Re: Case No. 21-277-EL-BGN - In the Matter of the Application of Border Basin I, LLC for a Certificate of Environmental Compatibility and Public Need to Construct a Solar-Powered Electric Generation Facility in Hancock County, Ohio.

Response to Fifth Data Request from Staff of the Ohio Power Siting Board

**BORDER BASIN I, LLC'S
RESPONSE TO THE FIFTH DATA REQUEST
FROM THE STAFF OF THE OHIO POWER SITING BOARD**

EXHIBIT 1

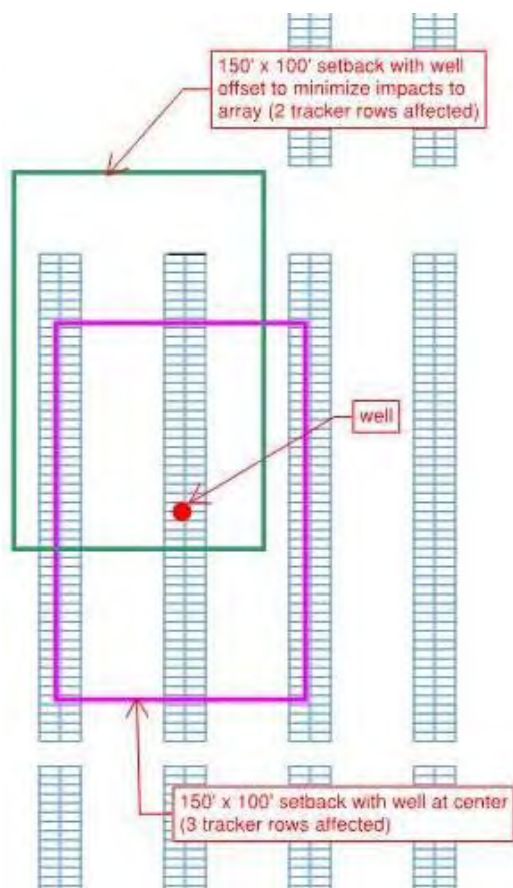
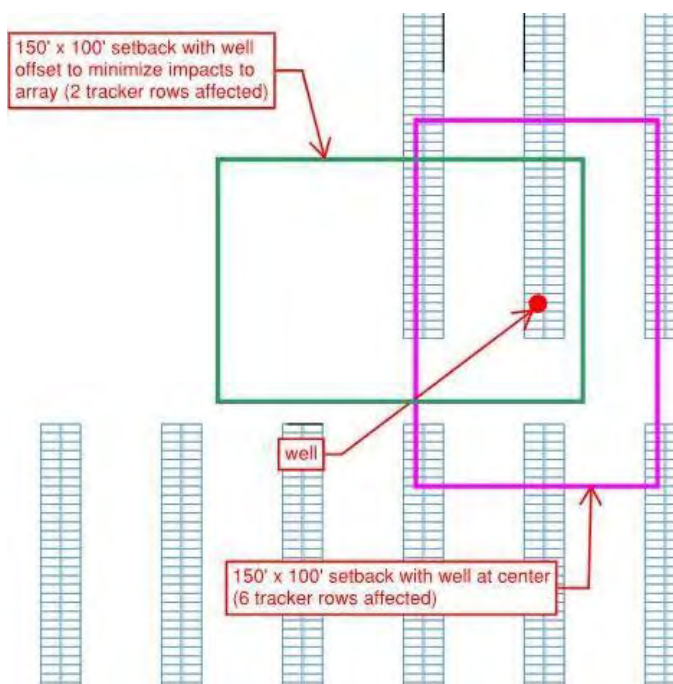
Wood understands that a 100- x 150-foot area is needed for plugging operations. The plugging area does not need to be centered on the well itself. The plugging area configuration can be designed to impact the fewest strings based on the known threshold of modules impacted that triggers the removal of the entire string. In some cases, more tracker tables impacted may actually be beneficial as it likely means fewer modules per table will be impacted, possibly making for a lower overall impact if no full strings are triggered for removal. In addition, the ability to rotate the plugging area rectangle provides flexibility to minimize impacts. Exhibits 1 and 2 provide example plugging areas and their racker table impacts.

Figure No.

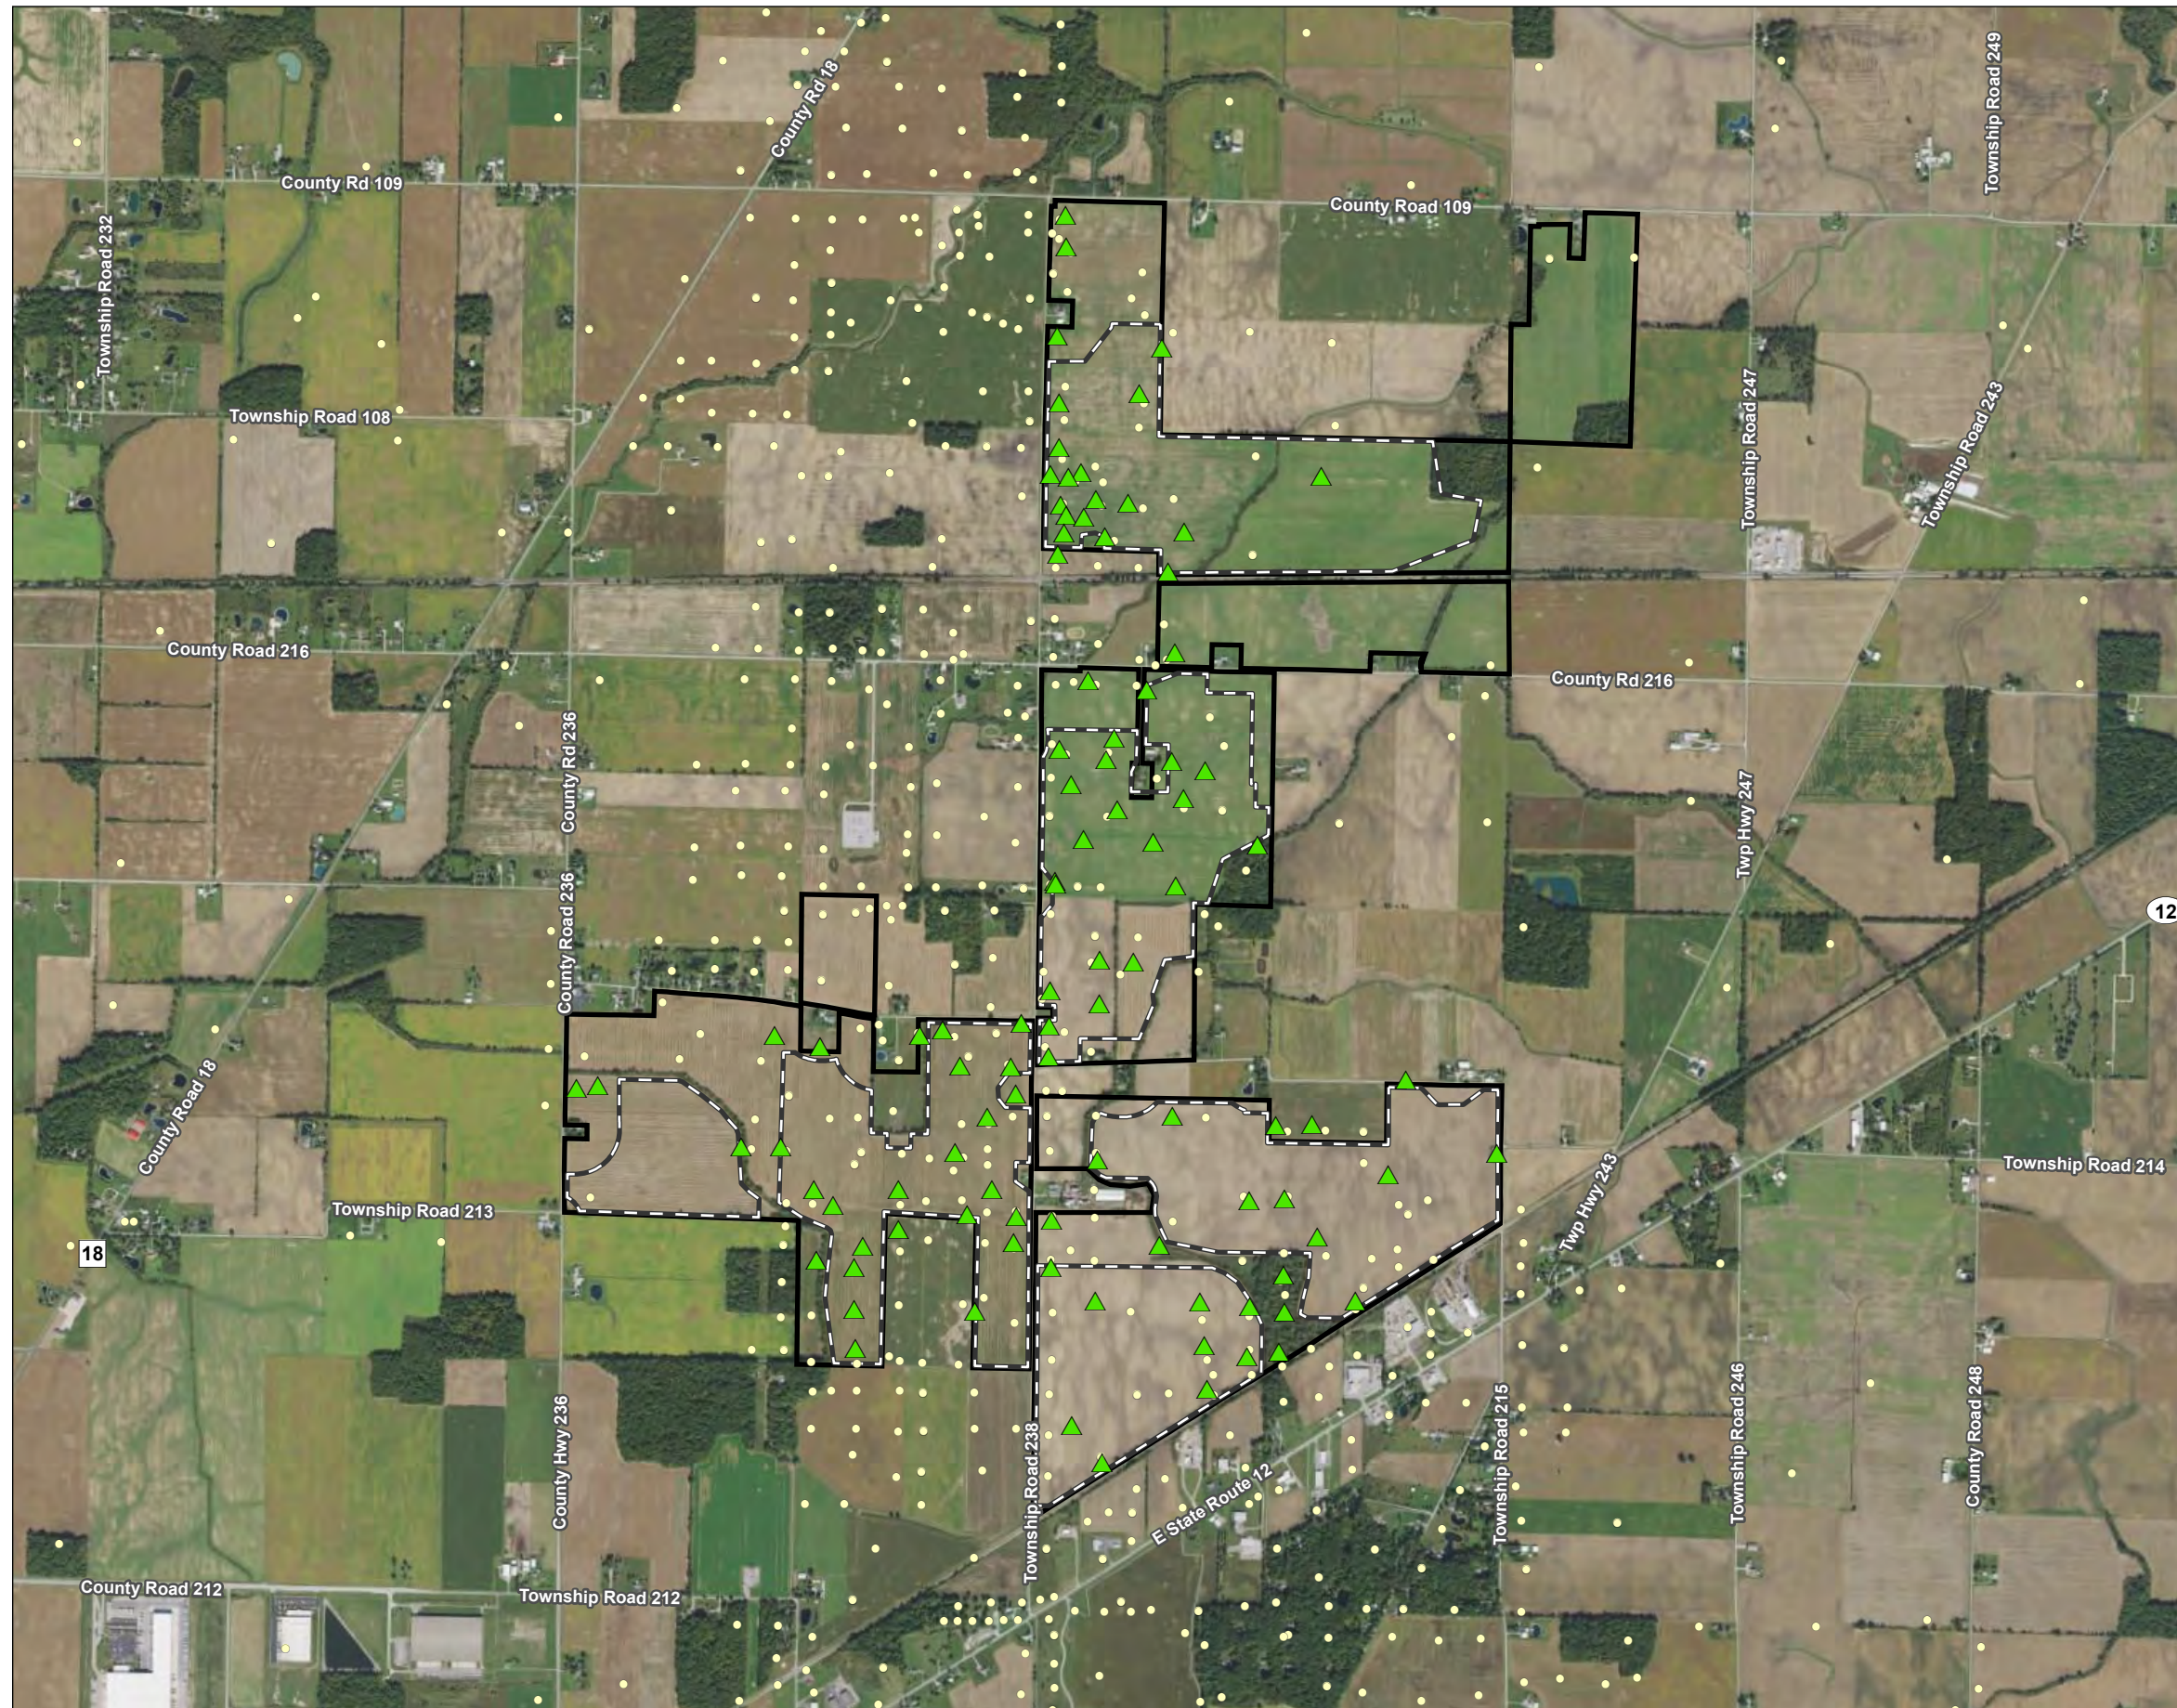
Response: Figure 3 in the ECR illustrates both the ODNR O&G well database well locations and status and the well-like anomalies identified by the EM surveys within the Project area. Section 1.2.2 of the ECR provides a detailed explanation of the ODNR oil/gas well database and its limitations. Section 1.3 of the ECR summarizes the EM survey process and results. The ECR also provides evidence and rationale why the well-like anomalies identified by EM surveys represent the most probable locations of historical O&G wells.

In addition to the maps provided by UAV Exploration in **Appendix D**, the well-like anomalies are also shown on **Figure 2** so that a comparison between well-like anomalies and historical O&G well database well locations could be made. Some of the well-like anomalies identified by the EM Survey are within 100 feet of ODNr historical O&G well mapped locations. However, locations of the majority of well-like anomalies and ODNr mapped wells do not appear to correlate.
